**FOLLOW-UP TO SUMMARY OF APRIL 28, 2022, NRC/DOE TELECONFERENCE
TO DISCUSS TECHNICAL REVIEW REPORT RELATED TO TANK 12H**

The following information is being provided in response to U. S. Nuclear Regulatory Commission (NRC) questions posed in Appendix B of their Technical Review Report (TRR) *Technical Review of Documents Related to Tank 12H Grout Formulations, Grout Testing, Procedures, and Grouting Operations at the H-Area Tank Farm at Savannah River Site*. [Reference 1] Questions were discussed in the NRC-U.S. Department of Energy (DOE) teleconference held on April 28, 2022, however, due to time constraints not all questions were able to be reviewed. [Reference 2] DOE agreed to provide written responses to questions that were not discussed or required further clarification. Additionally, NRC pointed to 10 specific follow-up action items in an August 18, 2023 communication. [Reference 3] Responses to the follow-up action items are provided below following the numbering system used in Appendix B of the TRR, the teleconference summary, and Action Item numbering in the August 18, 2023 communication. Follow-up action items are highlighted in light blue.

Figure 1: Tank 12 Riser 3 Spray Chamber

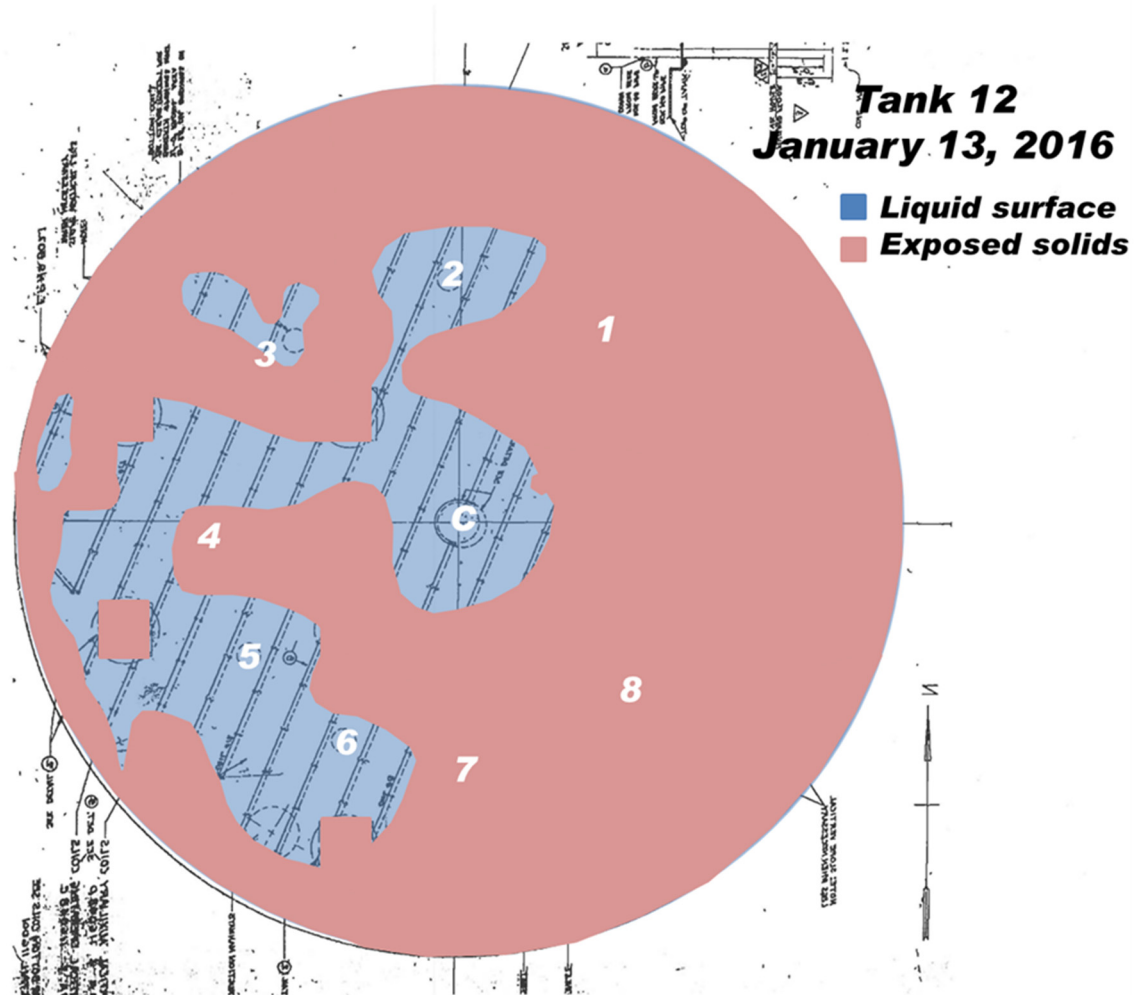
NRC requests DOE confirm that grout was being placed into Riser 3 when grout leaked around a riser cover port plug at Riser 7. NRC also requests DOE provide illustrations

or photographs of typical spray chambers associated with tank risers to better understand how the spray chambers interfere with riser grouting observations. Finally, NRC requests that DOE provide illustrations or photographs of typical riser cover port plugs.

Response: Grout was being placed into Riser 3 when liquid was reported exiting Riser 7. Spray chamber information provided in Attachments 3 and 4 of this letter (Drawings D180209 and W727076). Figure 1 provides an external photo of Riser 3 with the grouted in place spray chamber. A photo of Riser 7 during the closure process is provided in Figure 2 to show the associated riser cover port plugs.

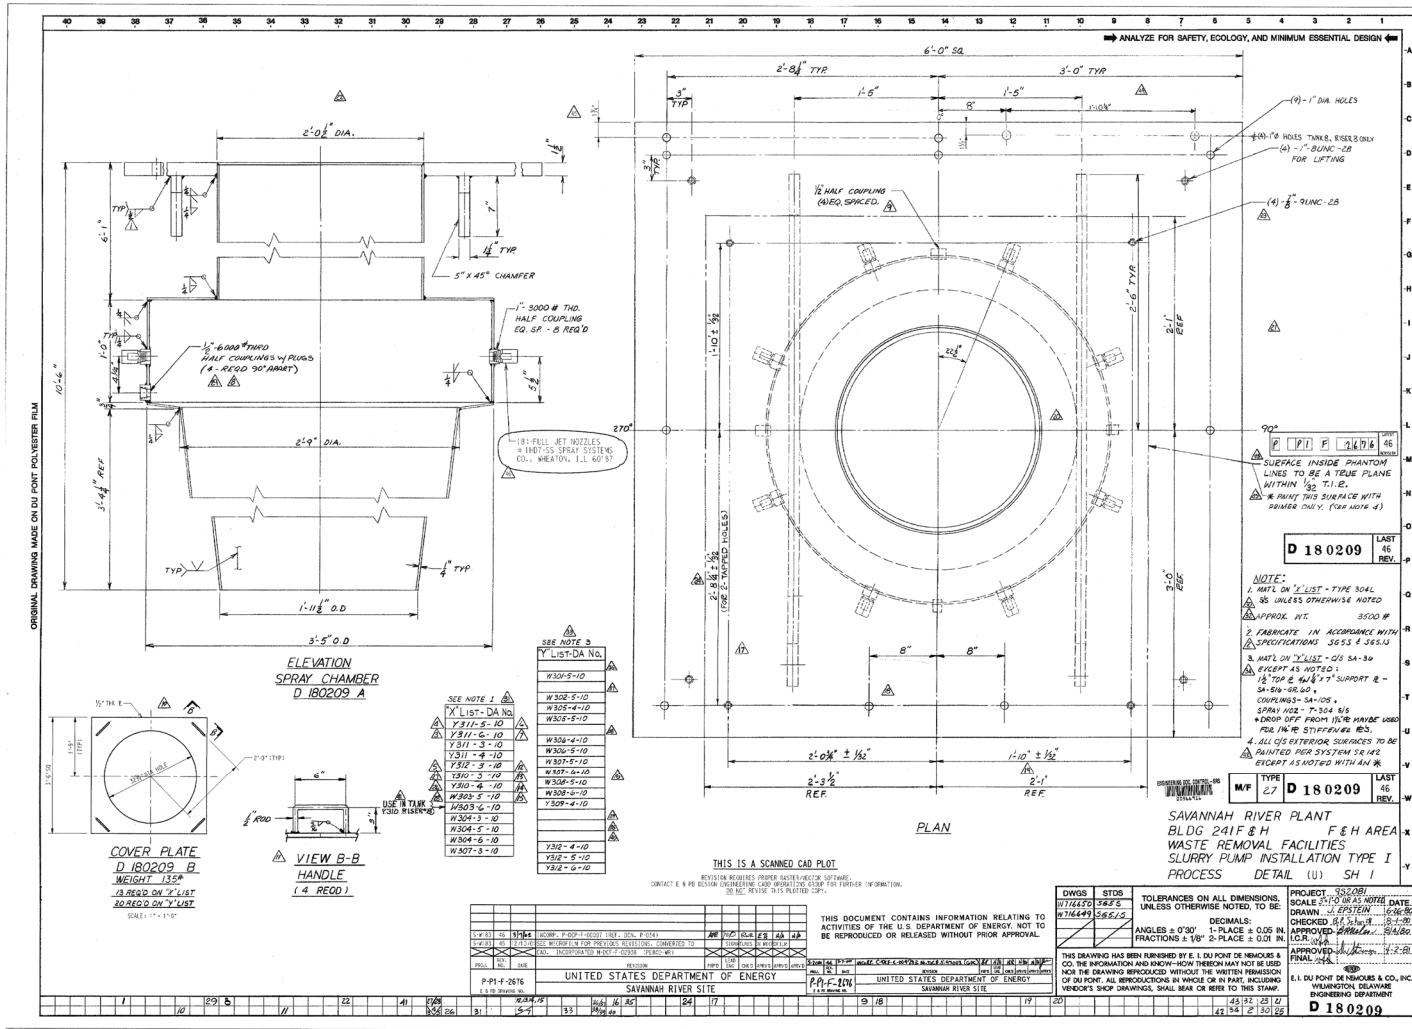
Cooling Coil Flushing & Grouting: With regard to WO 01337683-31-F (Coil Grout Spreadsheet), please explain why this spreadsheet addresses only 5 of 8 intact coils, and why the coil capacity noted here differs from the required flush volumes per coil (WO 01337683-31-A).

Response: WO 1337683-31, Attachment F, Pages 1 and 2 are included as Attachment 2 to this letter.
